WASHINGTON
UNION STATION
STATION EXPANSION

Appendix A5e – Action Alternatives Refinement Report

MEMORANDUM

SUBJECT: Bus Facility Design Considerations

Figure 1

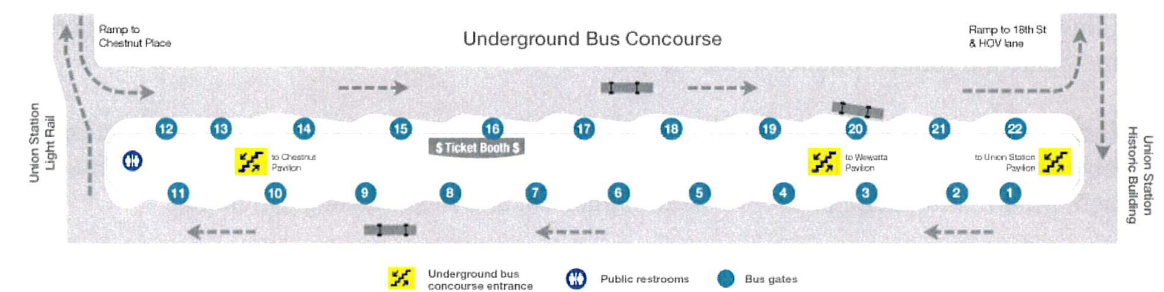
The City of Denver has recently completed an underground bus deck which is 1,000 feet in length, is the size of three football fields, and was designed with 22 gates with shallow angled bus slips (see Fig 1). It provides ample room for buses and passengers to maneuver which will allow buses to depart every 48 seconds according to the project documents.
